<p>This consultation response uses extracts of maps from <i>A66 Northern Trans-Pennine project – Routes for consultation General Arrangement drawings as reference points for comments relating to Cumbria only.</i></p>	<p>Project proposals</p>	<p>Comment</p>
<p>General comments:</p> <ol style="list-style-type: none"> 1. Many opportunities have been missed for providing additional linking public rights of way for pedestrian / pedal-cycle / horse along the whole of the proposed route. 2. Where there are no adjacent minor roads which peds / cyclists / horse riders may use as convenient alternative to the A66 such provision should be made as part of the A66NTP project. 3. Some of the proposals relating to public paths are outside of the red-line. Does this mean that they will not be covered by the DCO and will have to be done by CCC? 		
<p>Statutory Consultation legend (p5)</p> 		<p>Change notation that gives much clearer indications of sections of routes that are the extinguished and created as part of diversion proposals.</p>

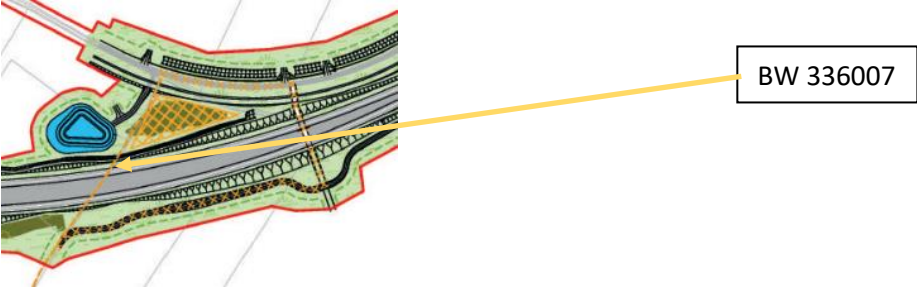
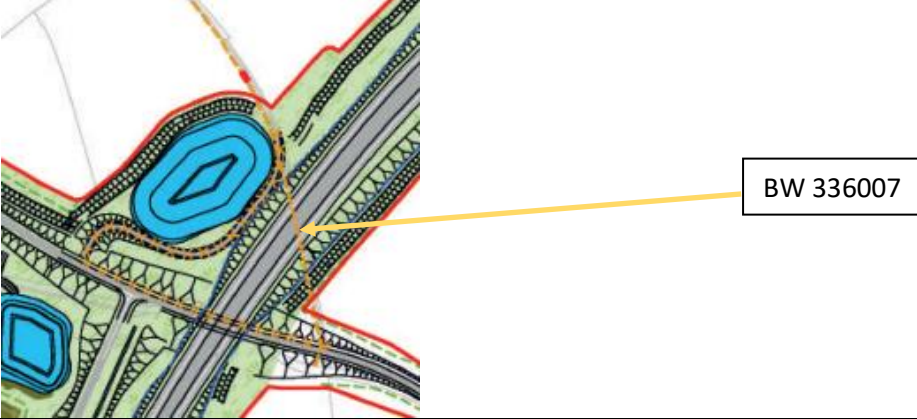
<p>M6 Junction 40 to Kemplay Bank (p7) – public path 358008</p> 	<p>Footpath to be diverted onto roundabout above underpass.</p> <p>Proposals shown outside of DCO boundary.</p>	<p>Proposals are outside of the red-line. Path and crossing arrangements to be such that pedestrians & cyclists can cross the roundabout without having to follow motor-traffic route.</p> <p>How are proposals outside of DCO boundary dealt with?</p>
<p>M6 Junction 40 to Kemplay Bank (p7) – Public path 358006</p> 	<p>No change</p>	<p>Is the termination of this path to be on the new slip-road? Should short section of path between A686 Carleton Ave. and the slip road be shown as extinguished (red cross-out)?</p>

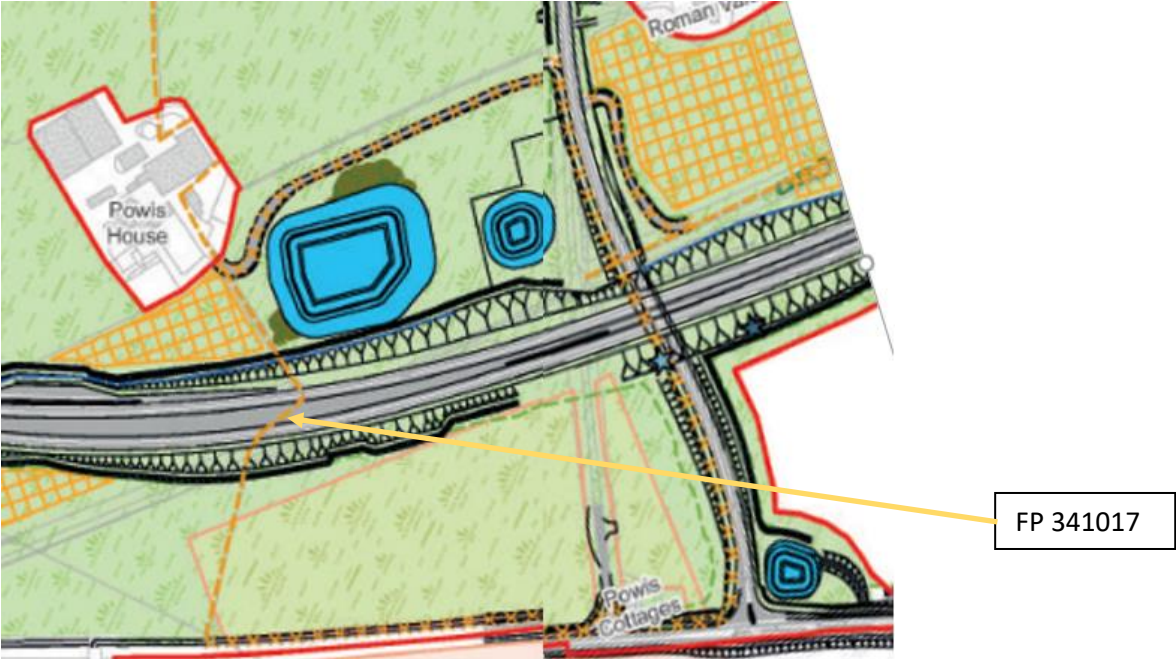
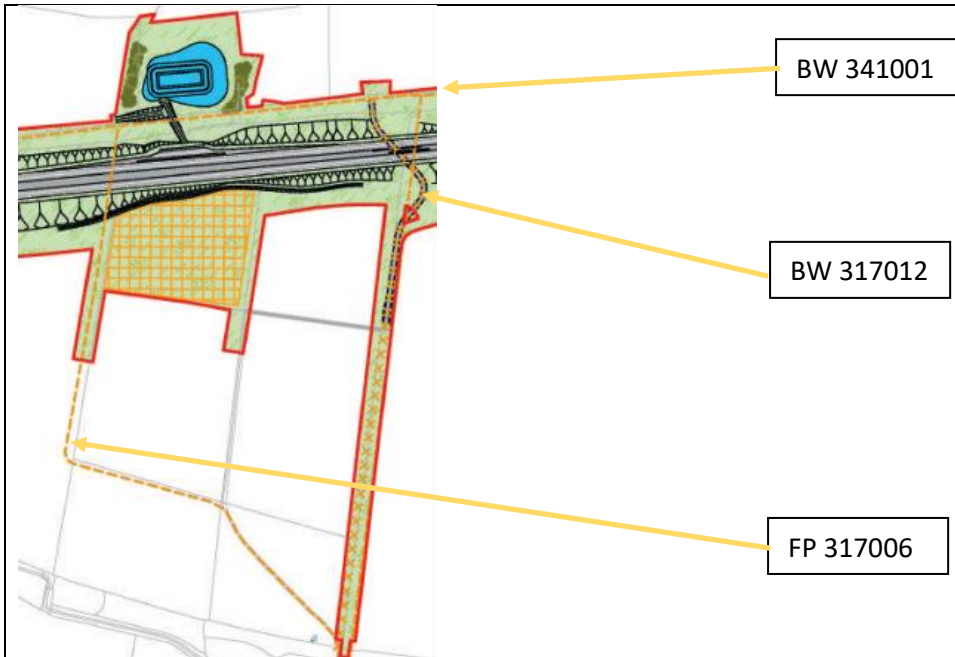
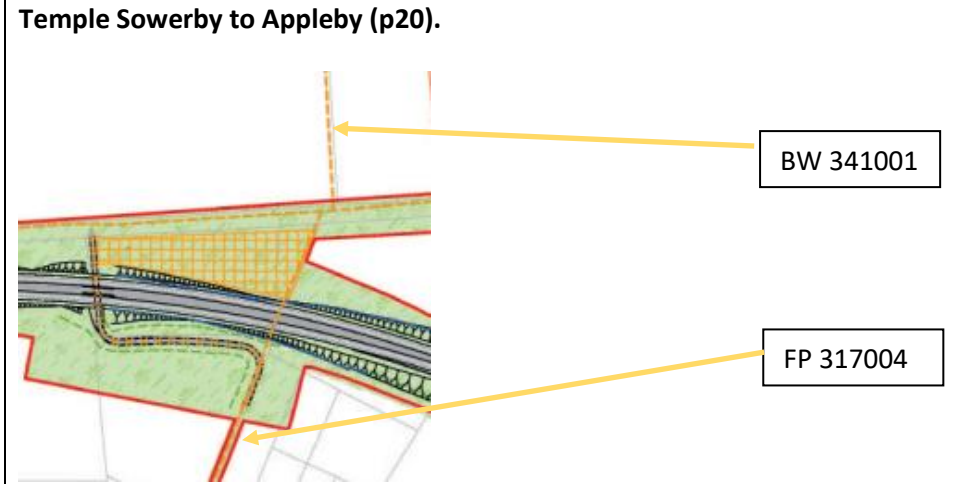
Project proposals	Comments
<p>Temple Sowerby to Appleby (p13) – Temple Sowerby link.</p> 	<p>BW 336007 to be diverted via underpass.</p>	<p>Section of proposed diversion route is superimposed on diverted Priest Lane (U3119). Is this a mapping error? Or is a definitive FP to be created alongside the U3119? Or is the path alongside the U3119 to be part of the U3119 (a footway)?</p>
<p>Temple Sowerby to Appleby (p15) – Temple Sowerby link.</p> 	<p>BW 336018 to be diverted around drainage pond to new point of termination on road C3030 (and over A66 via road bridge).</p>	<p>Section of proposed diversion route is superimposed on diverted C3030. Is this a mapping error? Or is a definitive FP to be created alongside the C3030? Or is the path alongside the C3030 to be part of the C3030 (a footway)?</p>
<p>Temple Sowerby to Appleby (p15) – Temple Sowerby link.</p> 	<p>FPs 336013 & 336017 to be diverted via a common bridge.</p>	<p>Consultation material states that bridge is for 'farm traffic, walkers, cyclists & horse riders' ... but the paths being diverted are footpaths only! The diverted paths and connecting paths (outside of the red-line) should be upgraded to bridleway in order that cycle and horse can avoid the proposed Kirkby Thore junction.</p> <p>Create new BW on this farm access track.</p>

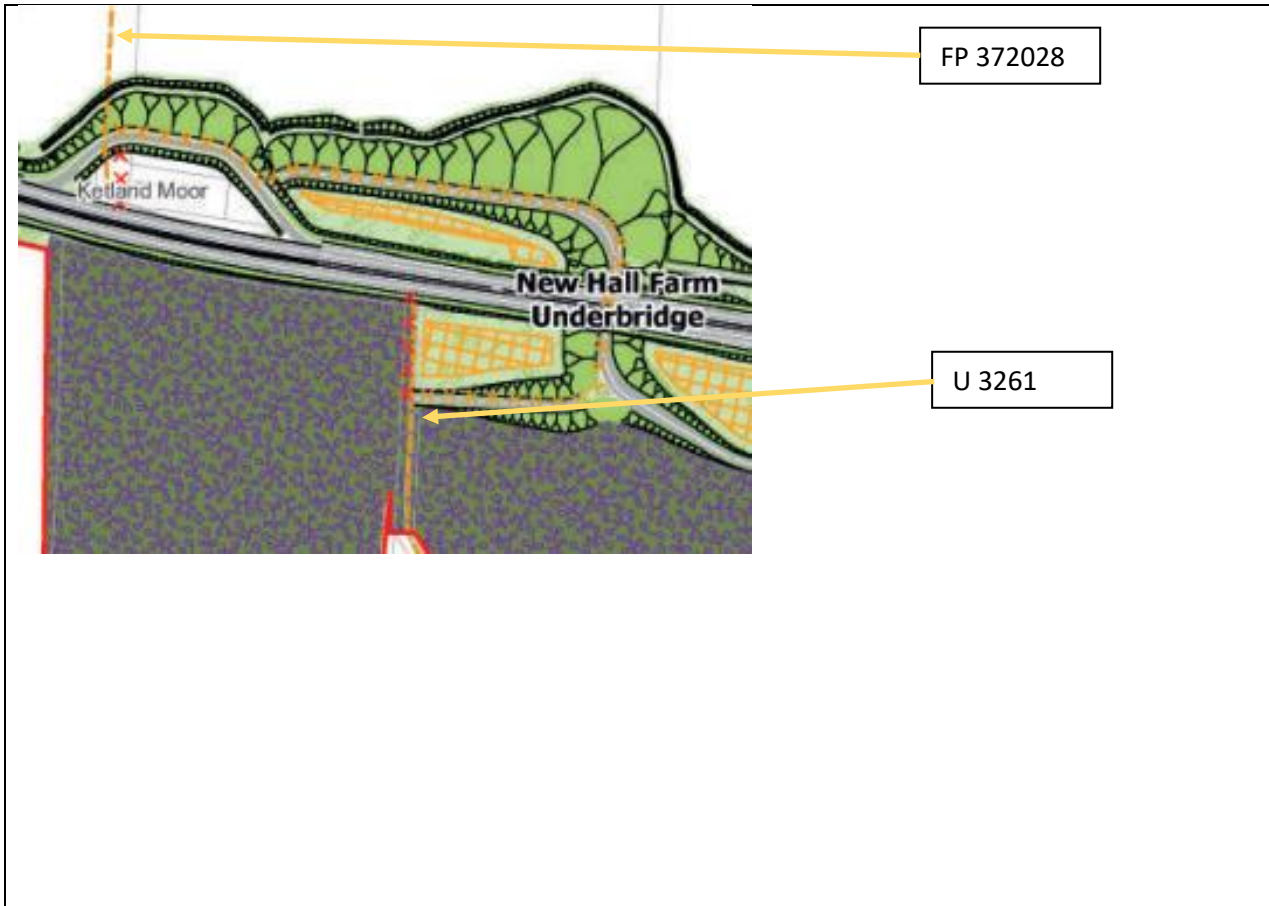
Project proposals	Comments
<p>Temple Sowerby to Appleby (pp17 & 18).</p> 	<p>FP 341017 at Powis House to be diverted to new termination at C3063 (Longmarton Road), over new Longmarton Road bridge and to old A66.</p>	<p>Section of proposed diversion route is superimposed on diverted C3063 and old A66. Is this a mapping error? Or is a definitive FP to be created alongside the C3063? Or is the path alongside the C3063 to be part of the C3603 (a footway)?</p>
<p>Temple Sowerby to Appleby (p 18 & 20).</p>	<p>Consultation mapping not totally clear here. It seems that FP 317016 is effectively being extinguished and ped'n traffic is to be directed along via new underpass to slightly diverted BW 317012 and new termination point with BW 341001.</p>	<p>Mapping requires clarification.</p>

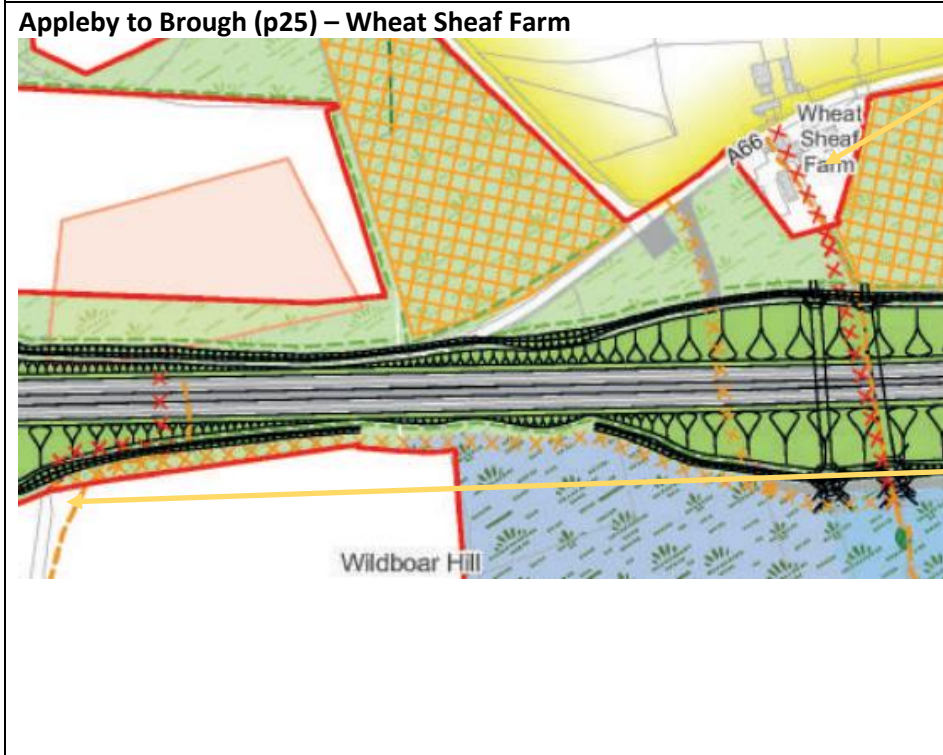
Project proposals	Comments
<p>Penrith to Temple Sowerby (p8) - B6286 junction, Brougham to Whinfell</p> 	<p>No apparent off-A66 provision for peds / cyclists / horse-riders.</p>	<p>Opportunity should be taken for adjacent network of farm and balancing pond access tracks to be dedicated as public bridleways / cycle tracks, to provide cycle-link west to Moor Lane at Brougham and east to Winderwath and Temple Sowerby.</p>
<p>Penrith to Temple Sowerby (p8) – Junctions to Whinfell Park Cottages and Ninekirks.</p>  <div data-bbox="996 606 1294 790" style="border: 1px solid black; padding: 5px; width: fit-content;"> <p>Byway Open to all Traffic 311013 & Unclassified county road U3192/102</p> </div>	<p>BOAT to be diverted. Access to Ninekirks (church).</p>	<p>Opportunity should be taken for adjacent network of farm and balancing pond access tracks to be dedicated as a Byway Open to all Traffic (BOAT) to provide a public link to Ninekirks road from the A66 westbound carriageway, and westward to Moor Lane at Brougham and east to Winderwath and Temple Sowerby.</p>
